STAFF RECOMMENDATION
108 Bowling Avenue
October 21, 2015

Application: Partial demolition; New construction—addition and outbuilding

District: Richland-West End Neighborhood Conservation Zoning Overlay

Description of Project: Application is to construct a ridge raise, an addition that is taller than the historic house, and an outbuilding, not to be used as a detached accessory dwelling unit. The project involves removing rear enclosed porches and a side exterior stair.

SITE PLAN 1/8" = 1 FOOT

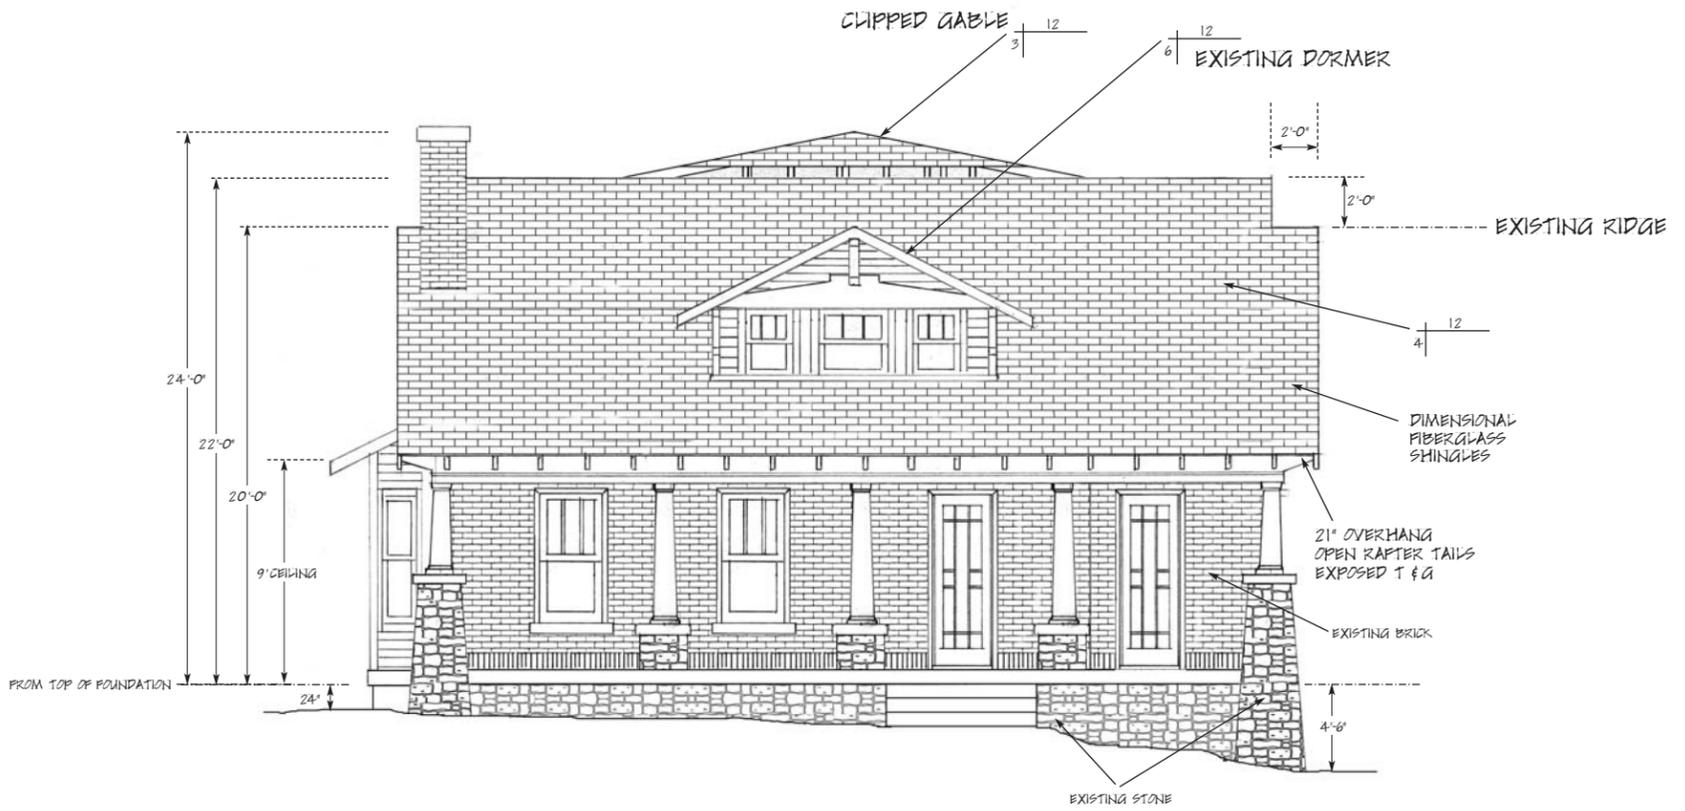
Outbuildings: See attached “Outbuilding Worksheet” for a full analysis of the appropriateness of the proposed outbuilding. The outbuilding will be located in the rear yard, accessed via the alley (Figure 8). It will be one story, with an eave height of nine feet (9’) and a ridge height of fourteen feet (14’), which is appropriate. Its footprint will be six hundred square feet (600 sq. ft.), and it will meet all base zoning setbacks. Its materials include five inch (5”) fiber cement lap siding, fiberglass shingles to match those on the house, and a concrete slab foundation. Staff

FRONT ELEVATION
1/4" = 1 FOOT

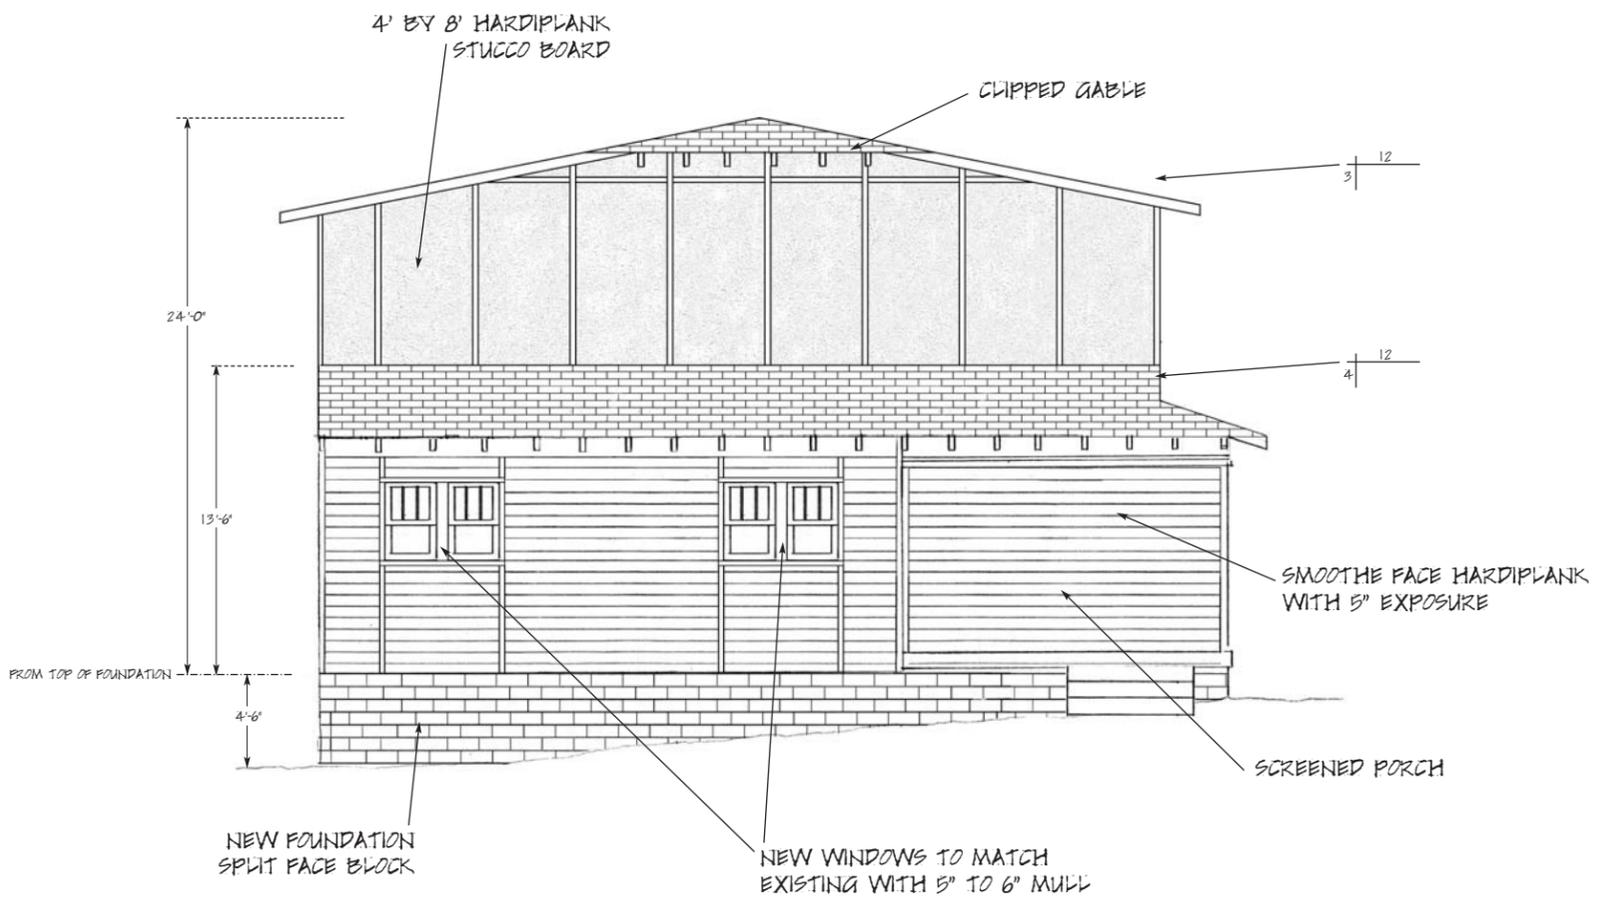
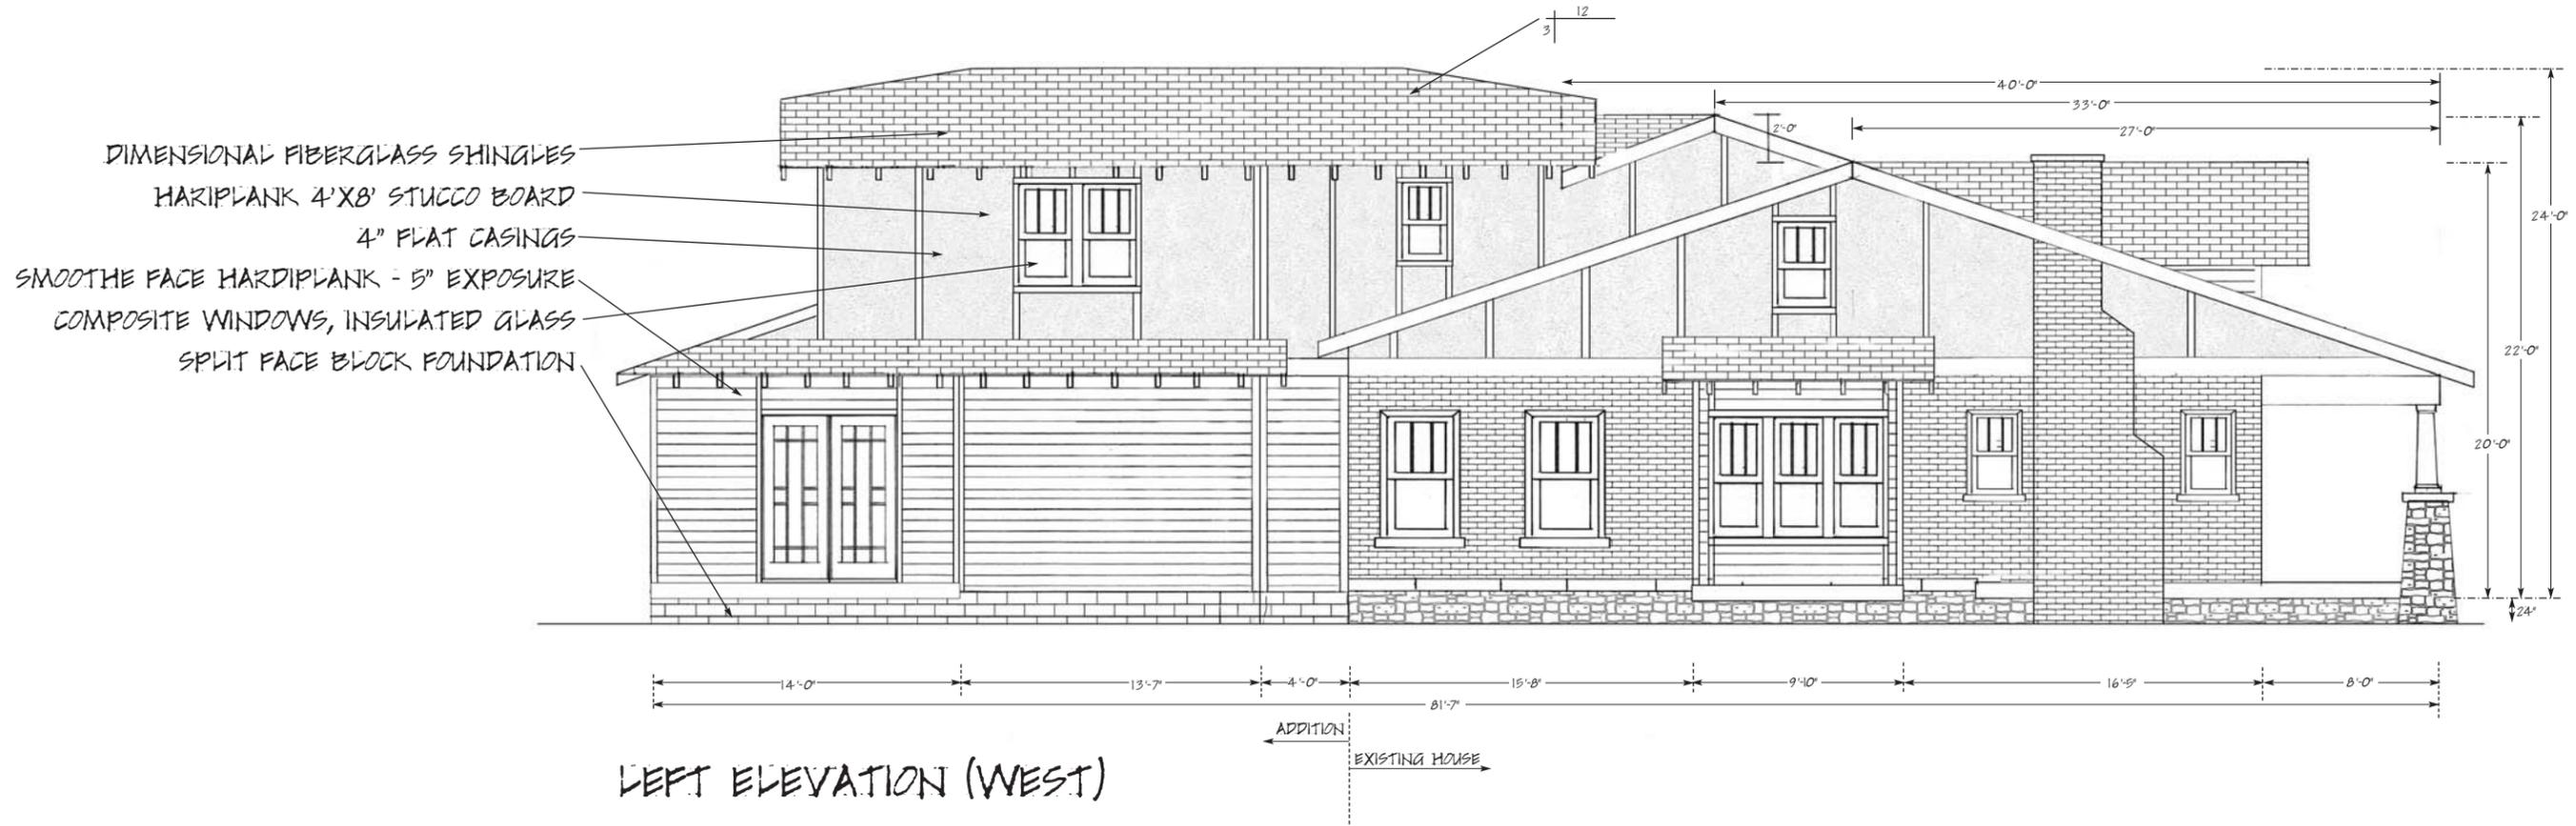
Height & Scale: The proposed addition involves a ridge raise. The ridge raise steps in two feet (2') and will raise the roof two feet (2') vertically in height. This meets the design guidelines. After the ridge raise, at a point more than forty feet (40') from the front of the house, the addition increases in height by another two feet (2') so that it is a total of four feet (4') taller than the historic house. Staff finds the addition's height to be appropriate because the taller portion of the addition has a clipped gable, helping to

reduce its visibility. In addition, the extra height is located over forty feet (40') from the front of the house, is inset appropriately and only approximately fifteen feet (15') of width is taller than the house.

Roof form: The historic house has a side gabled roof form with a 4/12 pitch. As described under “Height and Scale,” the addition involves a two foot (2’) ridge raise to the historic roof form. The ridge raise is appropriately inset two feet (2’). The rest of the addition will have a clipped gable roof form with a 3/12 pitch. Although a minimum 6/12 pitch is typically required, staff finds the lower pitch of the addition to be appropriate in this instance because the historic house has a low pitch. Staff finds that the proposed roof forms meet Sections II.B.1.e. and II.B.2. of the design guidelines.

TWO CAR GARAGE 1/4" = 1 FOOT

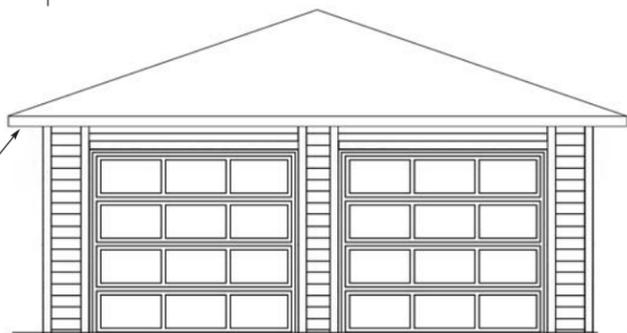
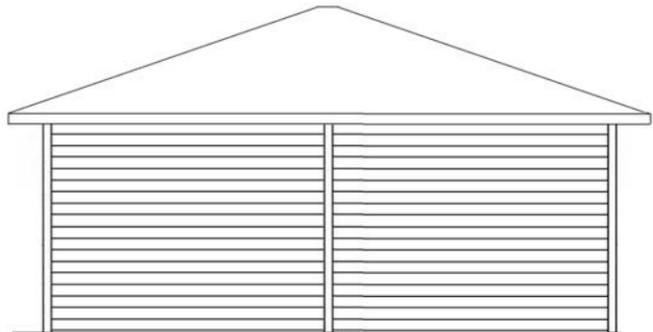
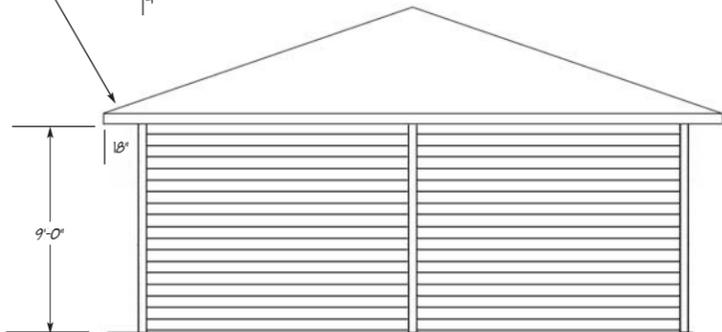
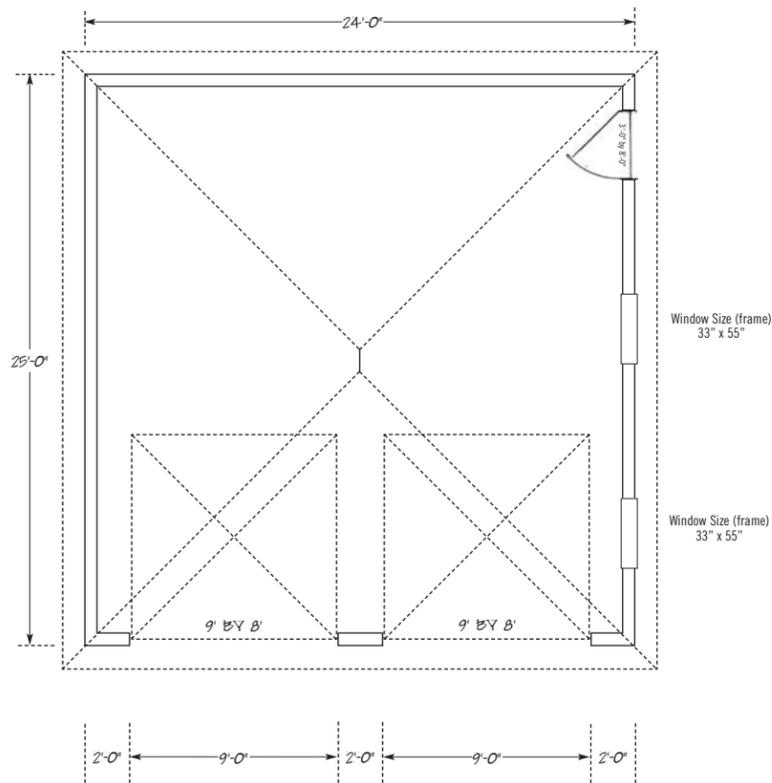
asks to approve the outbuilding's windows and doors prior to purchase and installation. Staff finds that the proposed outbuilding Section II.B.1.h of the design guidelines.
